City of Detroit
Inter-Departmental Communication

RE: Petition No. 809
Request for Conversion to Easement of the North/South Public Alley in the Block
Bound by Gratiot, Belvidere, Lambert, and Edsel Ford Freeway

NOTICE OF PROPOSED CHANGE IN PROPERTY

REQUEST TO CONVERT TO EASEMENT
 THE NORTH/SOUTH PUBLIC ALLEY, 20 FT. WD.
 IN THE BLOCK BOUND BY
 GRATIOT, BELVIDERE AVE., LAMBERT ST.
 AND EDSSEL FORD EXWY.

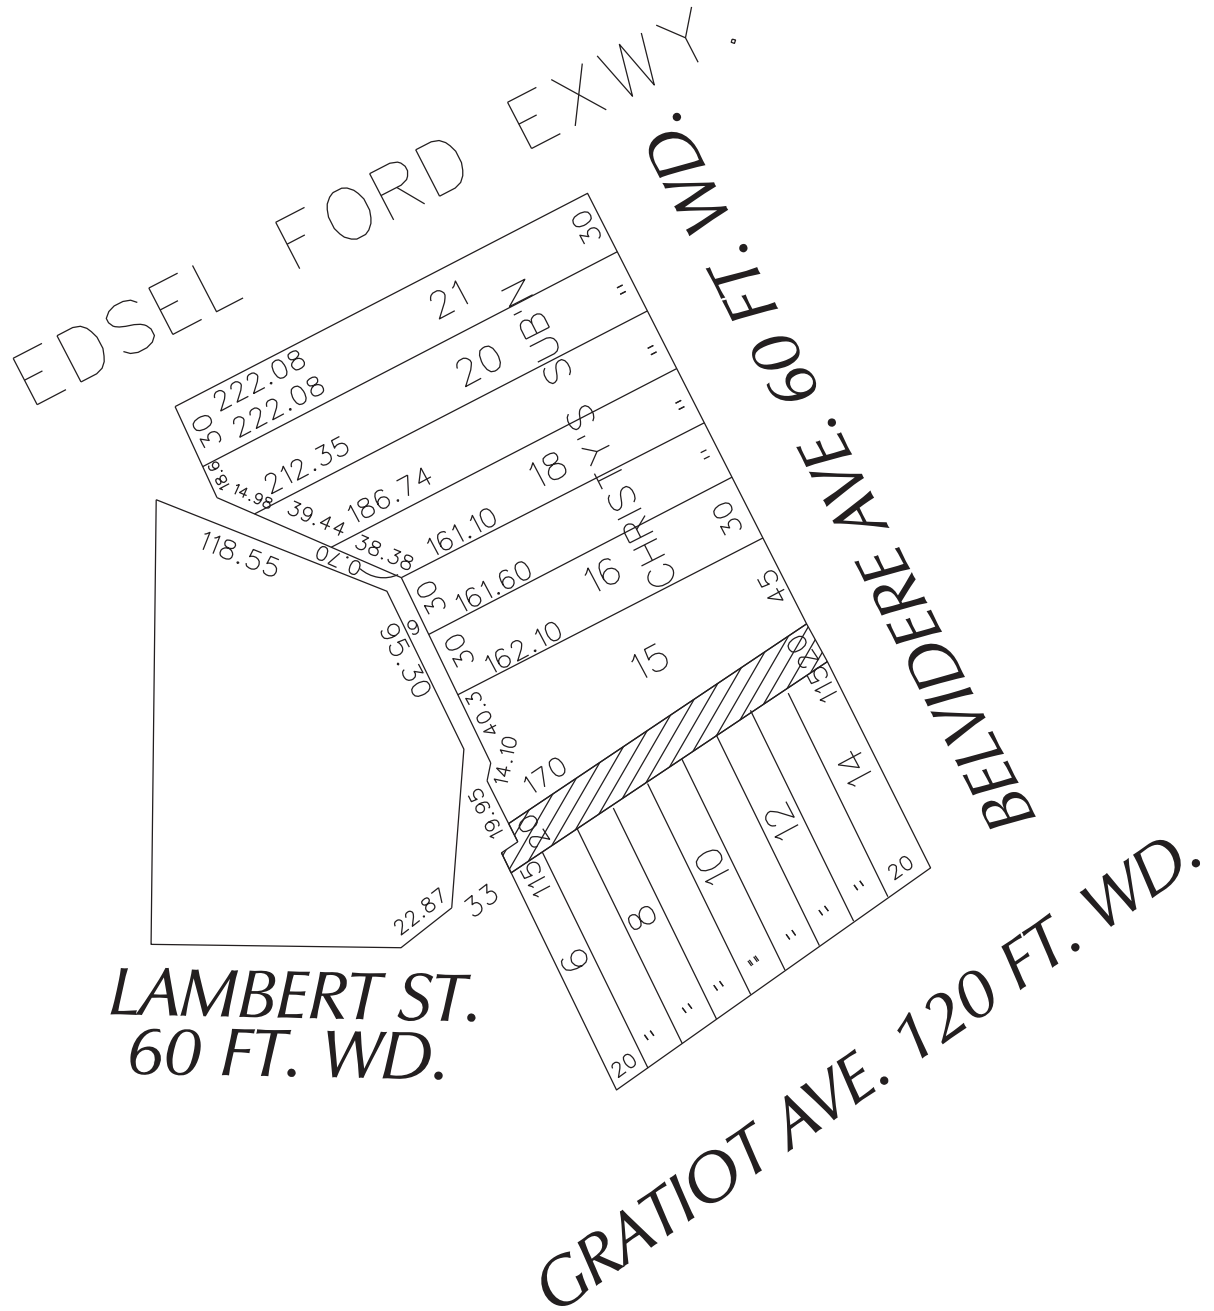
- Our records indicate that there is a sewer in the alley. DWSD has no objection to the requested conversion to easement provided that the attached Provisions for Conversion to Easement are strictly followed.

1. An easement, the full width of the existing right of way, is reserved for the Detroit Water and Sewerage Department for the purpose of installing, maintaining, repairing, removing, or replacing any sewers, water mains, fire hydrants and appurtenances, with the right of ingress and egress at any time to, and over said easement for the purpose above set forth.

2. Said owners of the adjoining property, for themselves, their heirs and assigns, agree that no building or structure of any nature whatsoever, including fences, porches, patios, balconies, etc., shall be built upon or over said easement, or that no grade changes or storage of materials shall be made within said easement without prior written approval and agreement with the Detroit Water and Sewerage Department.
